RIPON KNITWEAR LTD (EXTENSION)

Jarun, Konabari, Gazipur

DEA

Observation-03: Lack of a proper load-management plan (All Structure).

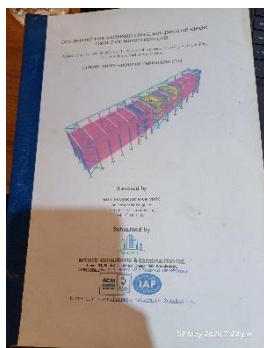
Description: No load markings and proper load management were evident. The building engineer is required to prepare the load plan following NTPA guideline section 4.13; post the floor load plan on each floor, provide load restriction height markings, signage on the storage area, and manage the floor load plan as per the acceptable load limits of BNBC.

4.	Lack of a proper load-management plan (Building-4)	The building engineer is required to prepare the load plan following NTPA guideline section 4.13, & post the load plan, provide load restriction height markings and signage for the storage area, and manage floor loading as per the load plan.	within 6 weeks
